City of Madison Site Plan Verification

PROJECT: LNDSPR-2020-00051

Address: 2004 Atwood AVE

Description: Temporary Outdoor Seating in parking lot for Restaurant-tavern, valid until October 25, 2020

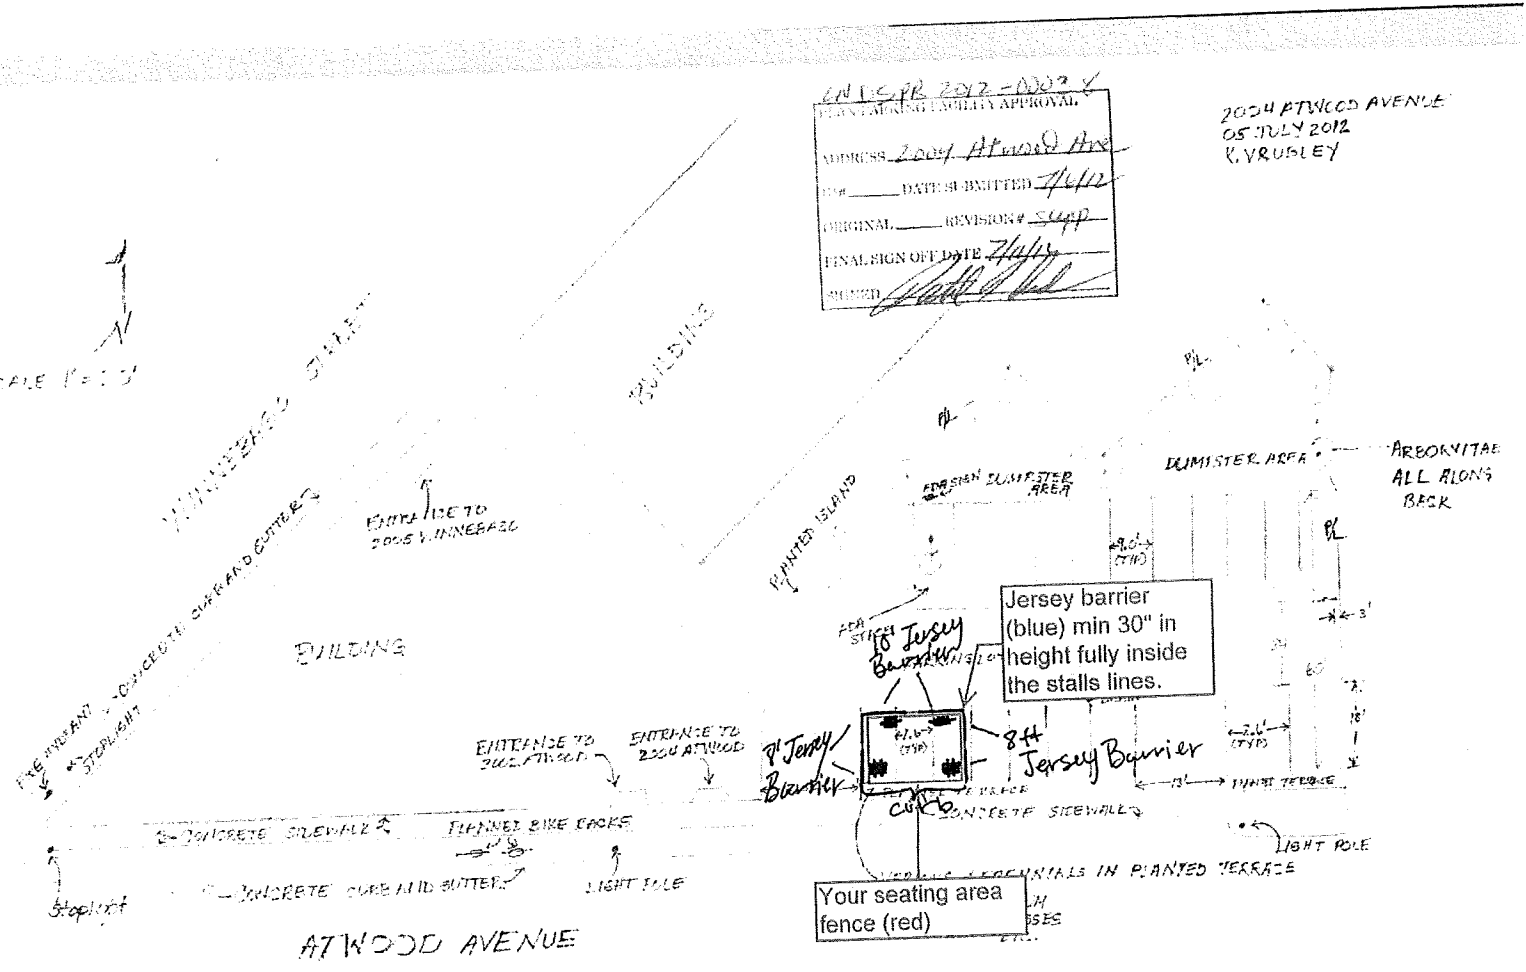
Applicant shall place a combination of jersey barriers, type 3 reflective barricades, reflective barrels/drums and wheel stops to secure the seating area and show and note this on the plan.
